Fingerboards Mineral Sands Project Inquiry and Advisory Committee

Technical Note

TN No: TN 039

Subject: Project overview - response to the IAC's request for information dated 26 May 2021 (Tabled Document 401), question 9

Figure 2 January tabled plans – proposed road network - diversions and staging (Tabled Document 45)

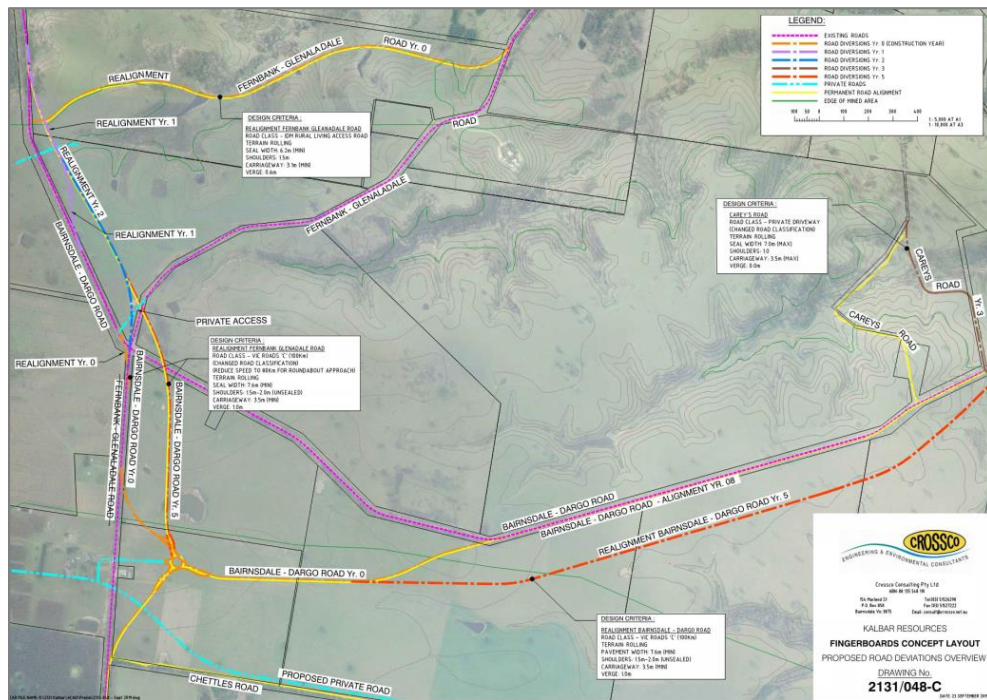
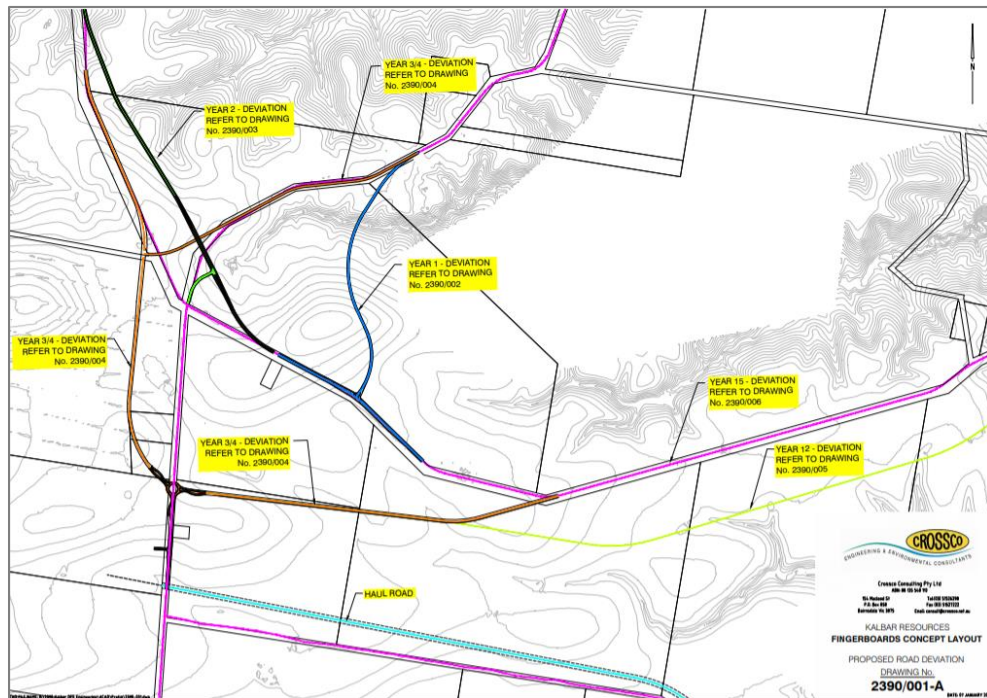
a) Location of proposed roads

The rationale for the changes in the January Plans was explained in Tabled Document 44. In short, these revisions facilitate more efficient mine sequencing, reduce the extent of ‘interim’ roads and locate the northern interim section of Fernbank Glenaladale Road (see blue in Figure 2) over less challenging topography.

Both sets of plans were assessed by Mr Hunt and Mr Carter in their evidence. Ultimately, the functionality achieved by both options is similar and acceptable, but would require road geometry refinements in accordance with Austroads design standards and detailed design to the satisfaction of the Department of Transport and East Gippsland Shire Council. Both options are either within the mine project area or infrastructure options area under the Specific Controls Overlay. Having regard to these factors, Kalbar is not asking the IAC to make a finding as to which of the road alignments is preferred, but rather to find that either would be acceptable, subject to the mitigations outlined in the EES and evidence, and subject to the controls proposed (i.e., the Traffic and Transport Management Plan requirements provided in the DoT’s version of the Incorporated Document).

Having said the above, the January Plans present Kalbar’s preferred road layout, for staging and efficiency reasons, whilst acknowledging that the road authorities will likely require refinements. The staging arrangements for these plans are shown via various colours and annotations. A simpler presentation of the January Plans is included as Attachment 1 to further assist the IAC and submitters (with the various stages shown on separate sheets, rather than differentiated through colours).

Figure 4 Project area and mining licence application (May 2021) area

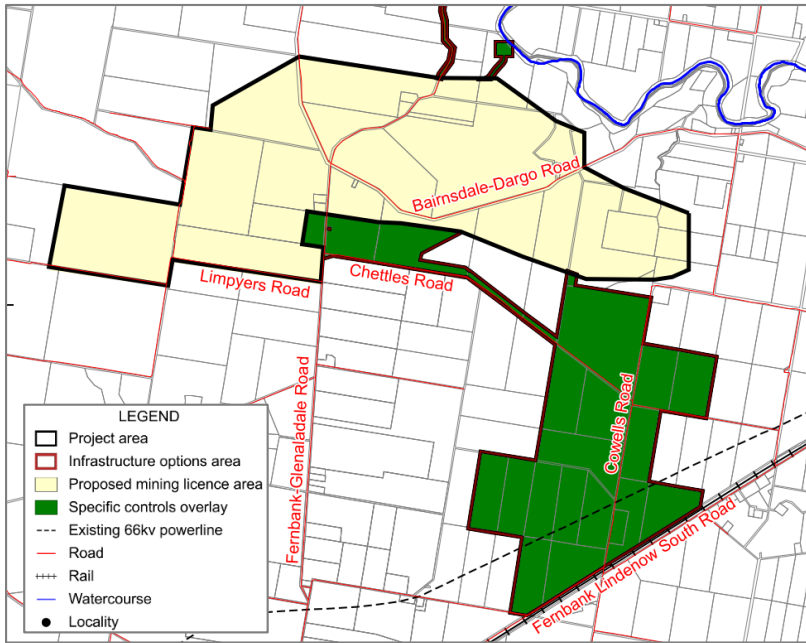
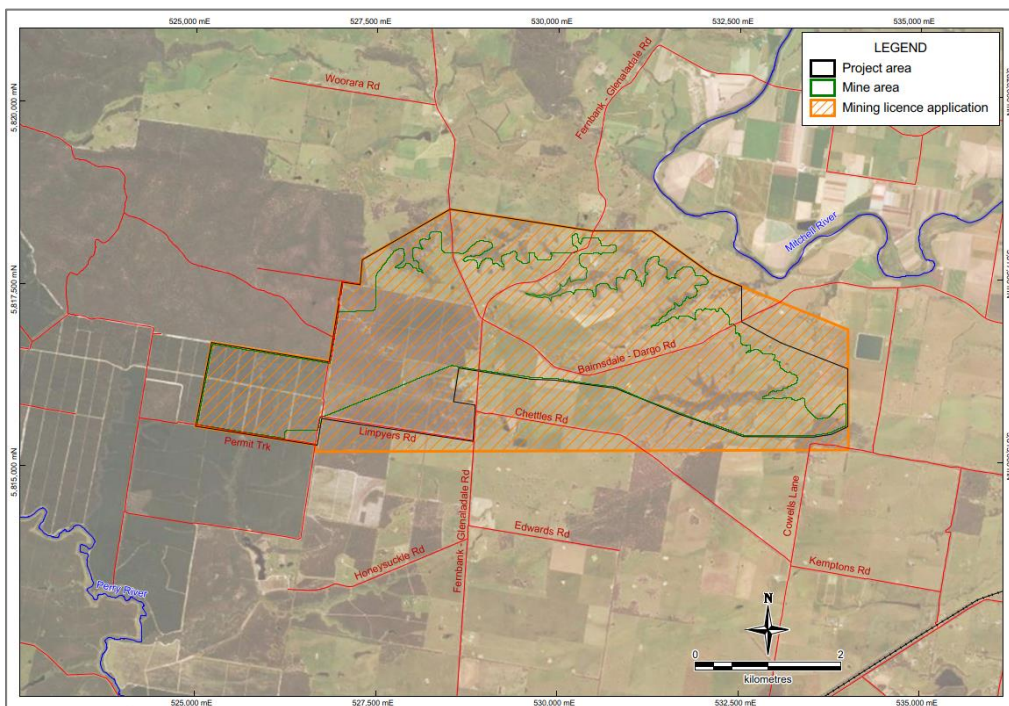
b) Previous and proposed mining licence extent

As explained in TN 032 (Tabled Document 518), on 13 May 2021, Kalbar lodged its application for a mining licence over a larger area than the Project area.

Figure 4 below shows the Project area, together with the mining licence application area (as per the May 2021 application). The change to mining licence application area does not change the area of land proposed to be mined (see further discussion in item (c) below).

The proposed mine footprint is shown by the green line in Figure 4 above. This is the same mine footprint shown in the EES (see, e.g., Figure 3 of the EES map book).

Figure 5 EES Appendix A006: App A extract, pdf p 42

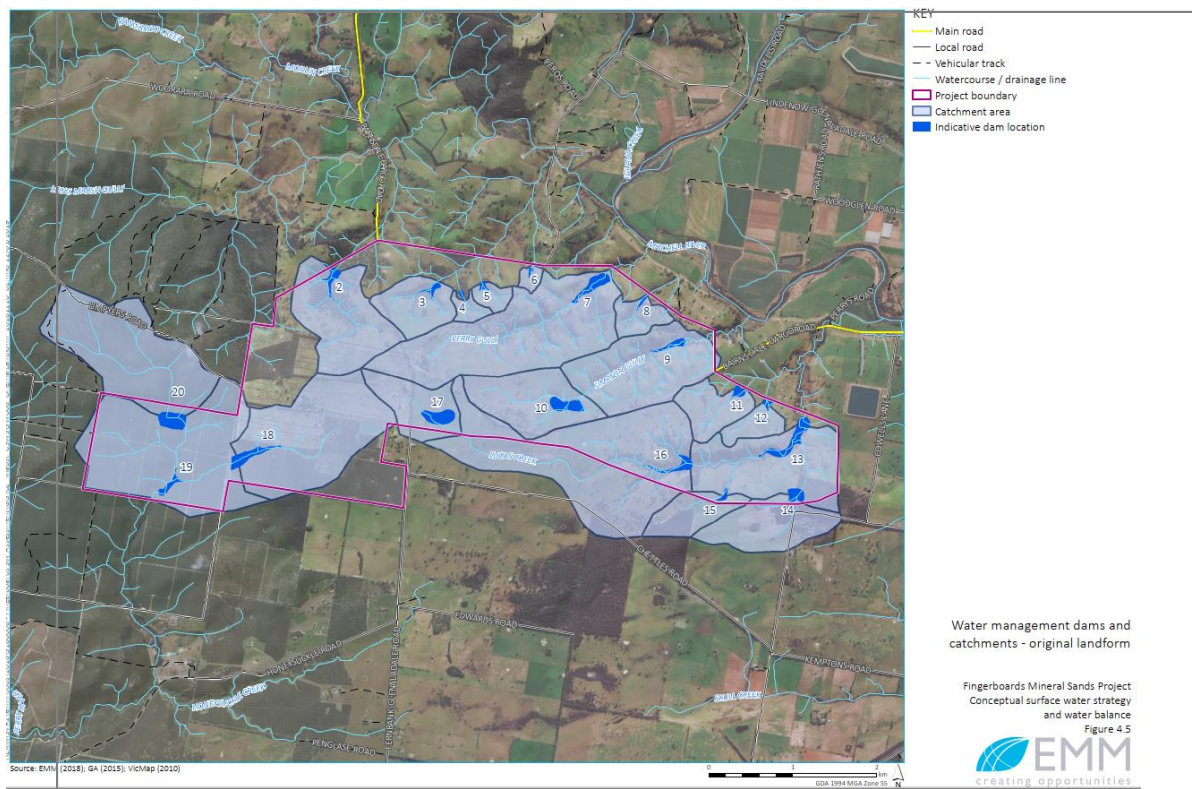
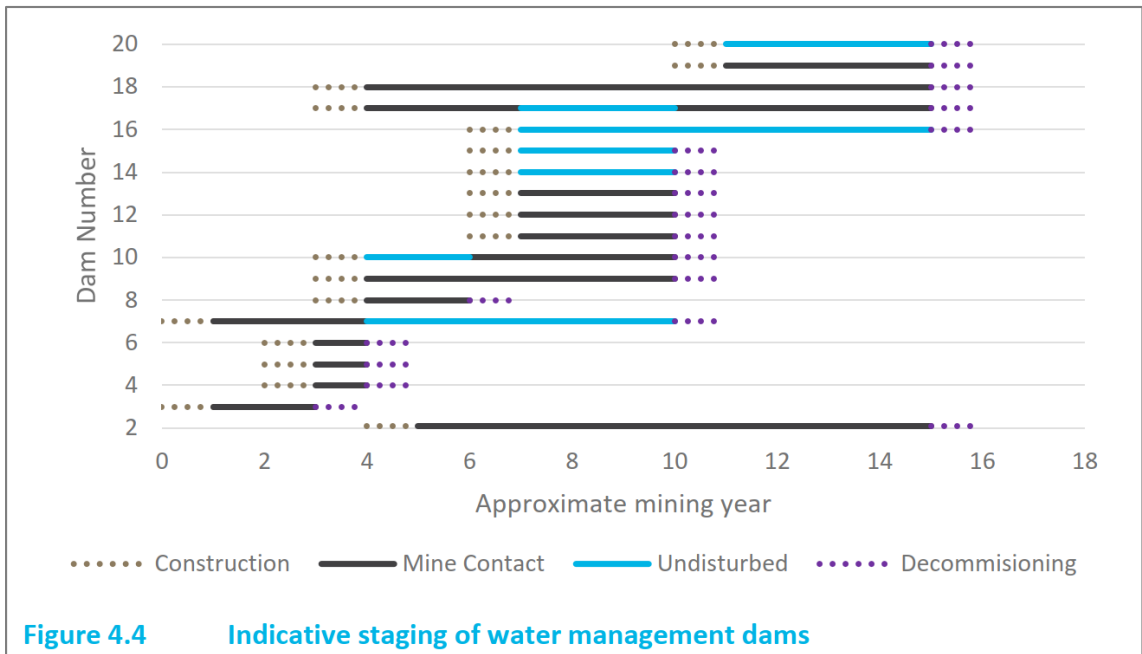
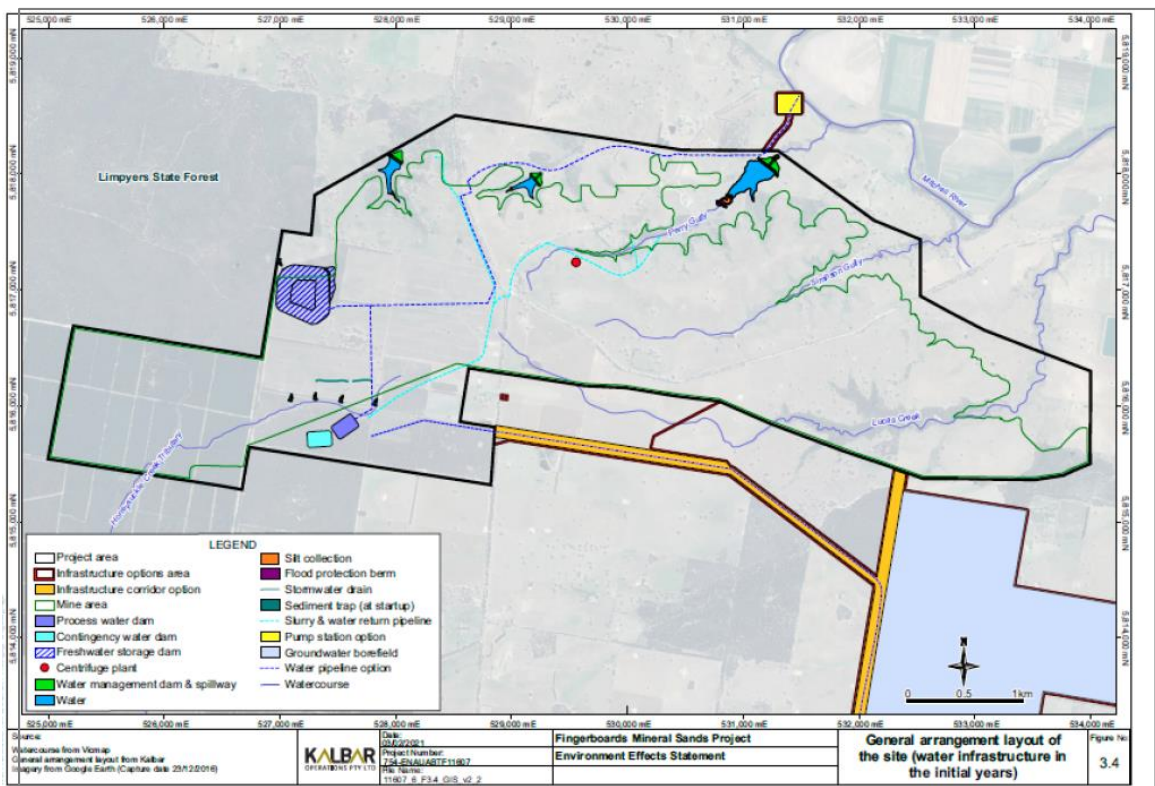
d) location of all proposed dams, including sequencing

Figure 4.5 within that report shows the indicative dam locations for the surface water management dams (extracted in Figure 5 below). The sequencing for those dams can be found in Figure 4.4 of that document (extracted in Figure 6 below).

Other water infrastructure, including the freshwater storage dam, process and contingency water dams is shown in Figure 3.4 of the EES Project Description (Chapter 3) (extracted in Figure 7 below).

Figure 8 Extract of Figure 8 from TN01 (corrected), Tabled Document 43a

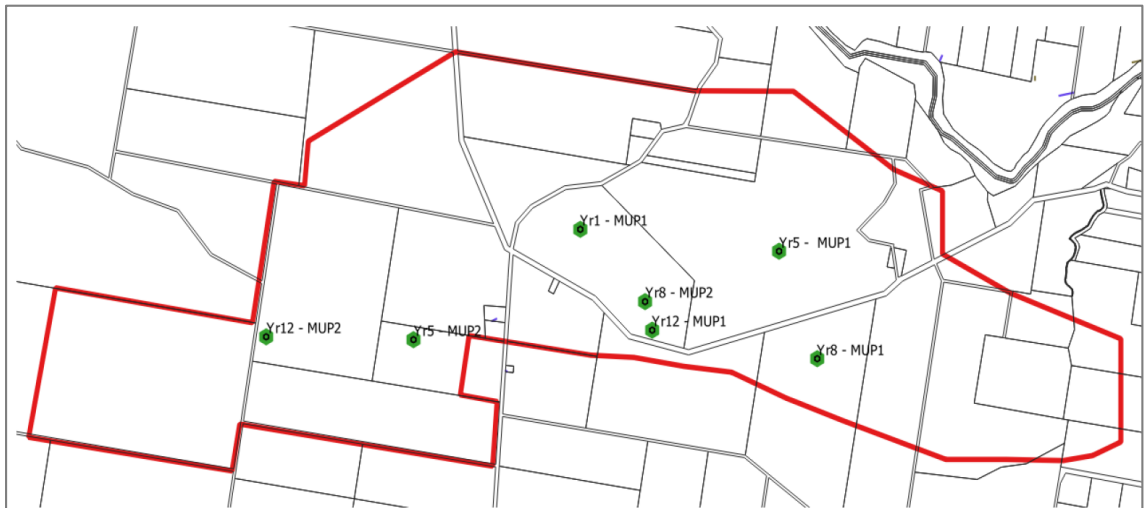
f) Location and scale of centrifuge building units and other fixed infrastructure and plant

Refer to Figure 8 of the Corrected TN01 (Implementation of centrifuges for water recovery and tailings management), Tabled Document 43a, for proposed centrifuge locations.

Figure 9 Centrifuge plant (MUP) including stockpiles – elevations

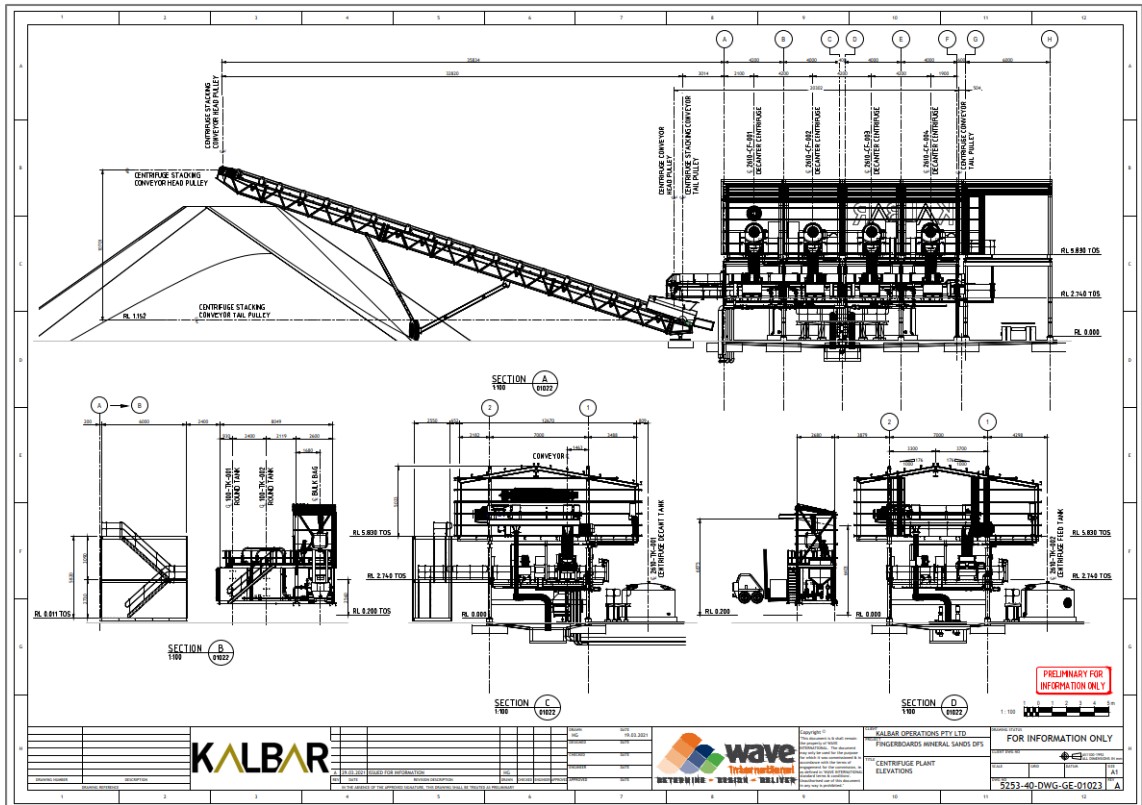
Centrifuge plant size

There are two relocatable centrifuge plants being proposed, known as MUP1 and MUP2. The full extent of the centrifuge plant is measured at 75.6m W x 54.2m D x 12.5m H. This includes all buildings and potential maximum stockpile footprint (refer extract from engineering plans in Figure 9 – with the full plan provided at Attachment 2).

Figure 10 Potential revised bore field location

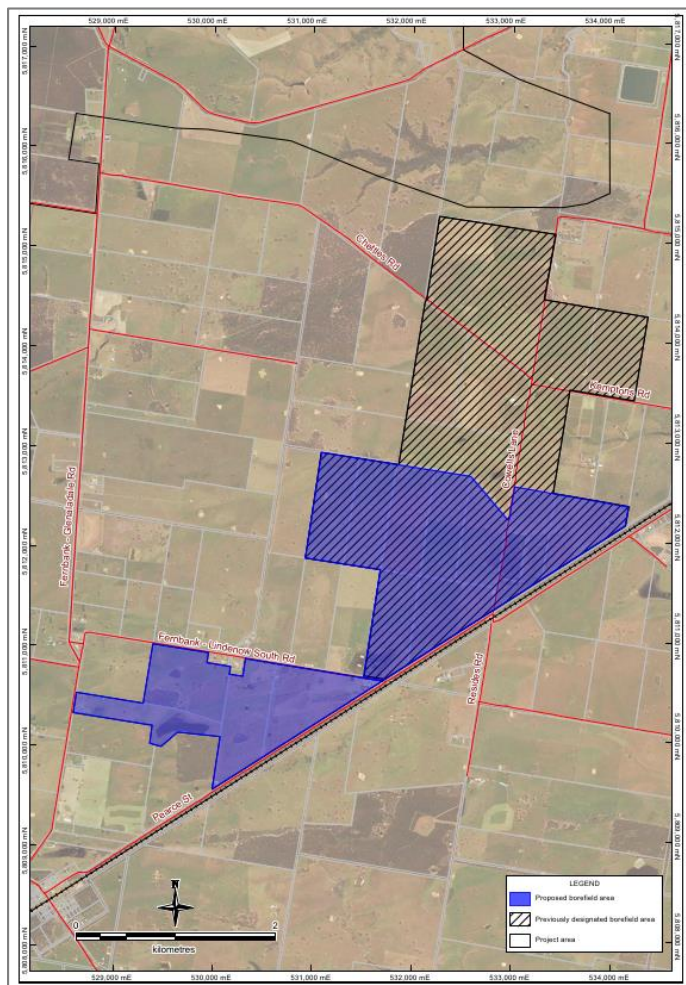
i) Proposed location of expanded borefield

Figure 10 shows the existing (exhibited – hatched) and potential revised borefield area (blue) (see Attachment 4 for original plan).

All property owners within these areas (existing and expanded) have granted access for the purpose of groundwater exploration drilling and the future use of the borefield.

Figure 12 Submission 813 map extract showing receptor 65 (red arrow)

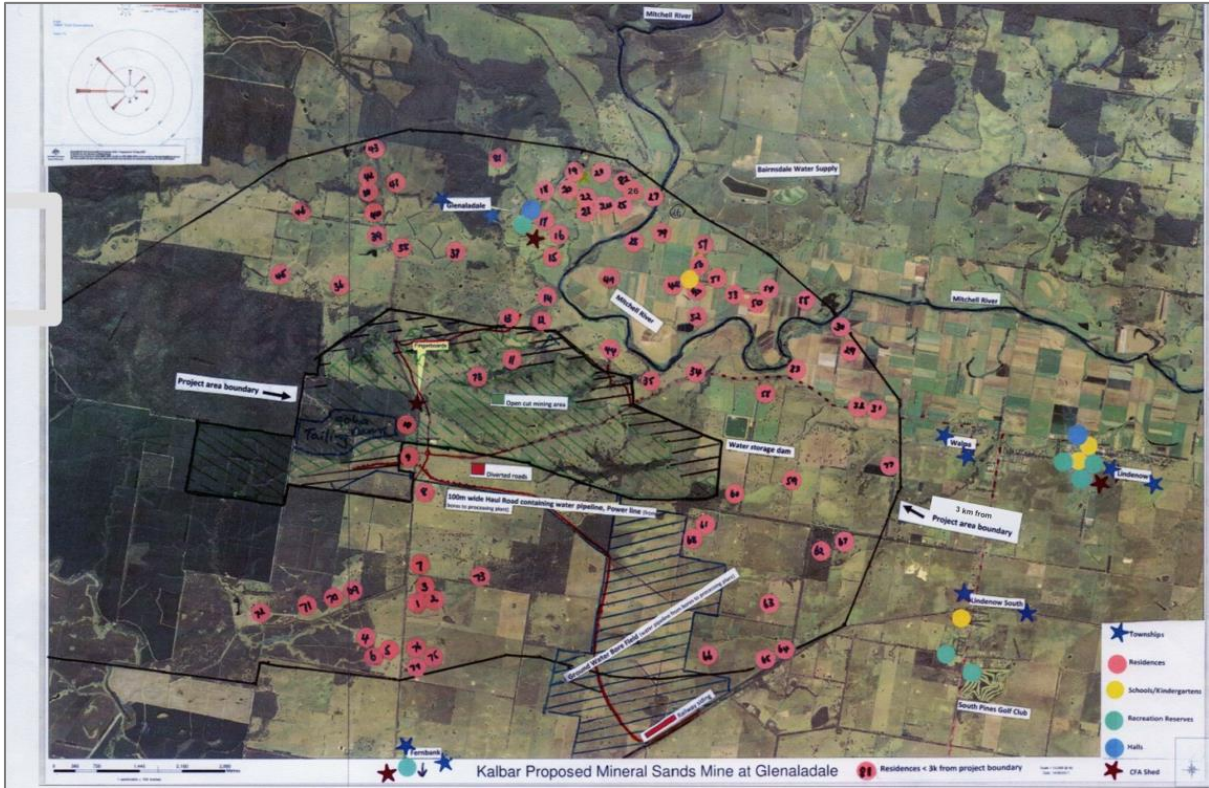
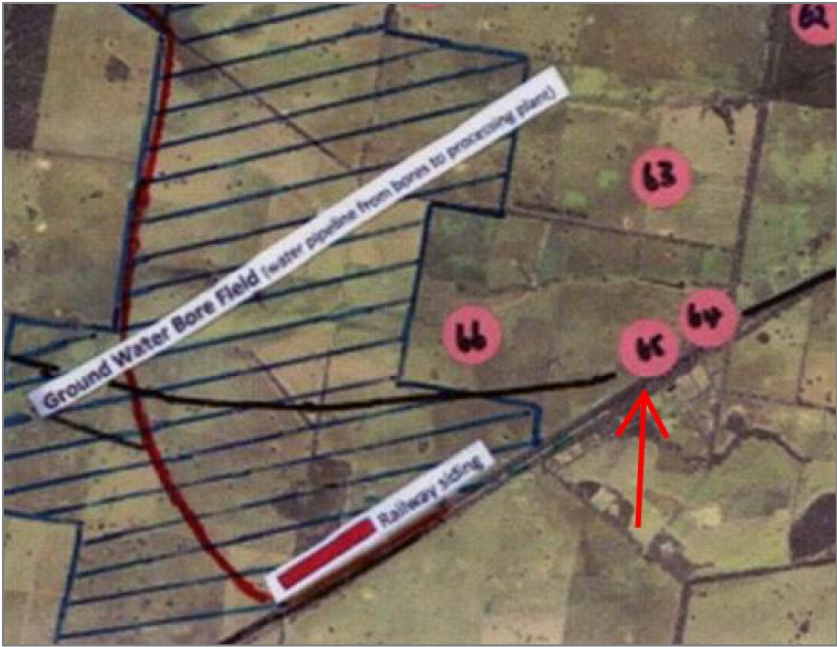
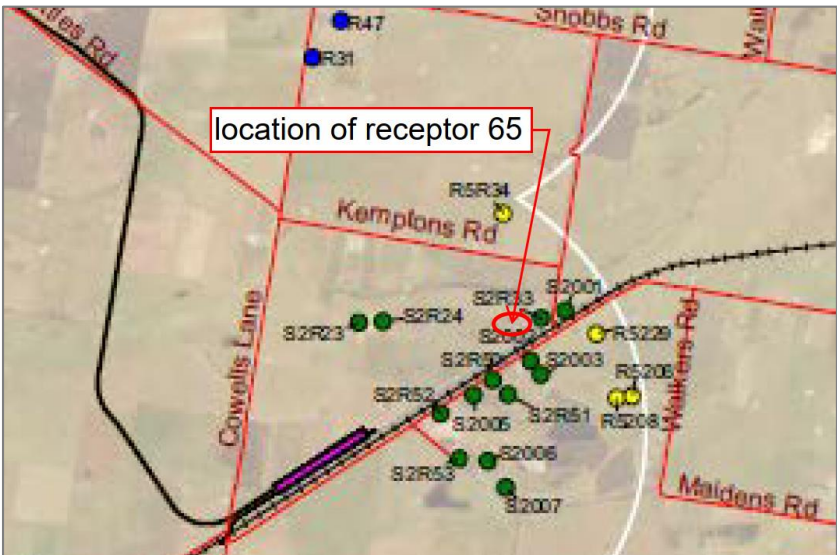
Kalbar notes the submissions made regarding potential discrepancies / errors in its identification of sensitive receptors, in particular, by reference to the receptor map shown on page 478 of Submission 813, extracted in Figure 11 below for reference.

Only one instance was identified where a residence was shown in the submission 813 map and not identified (i.e. missed) in the TN004 map. This is receptor 65. Refer Figure 12.

Several additional receptors are shown in the TN004 map closer to the rail siding than no. 65, as can be seen in Figure 13.

Accordingly, the identification of the additional receptor 65 will not affect the conclusions of the air and noise assessments.
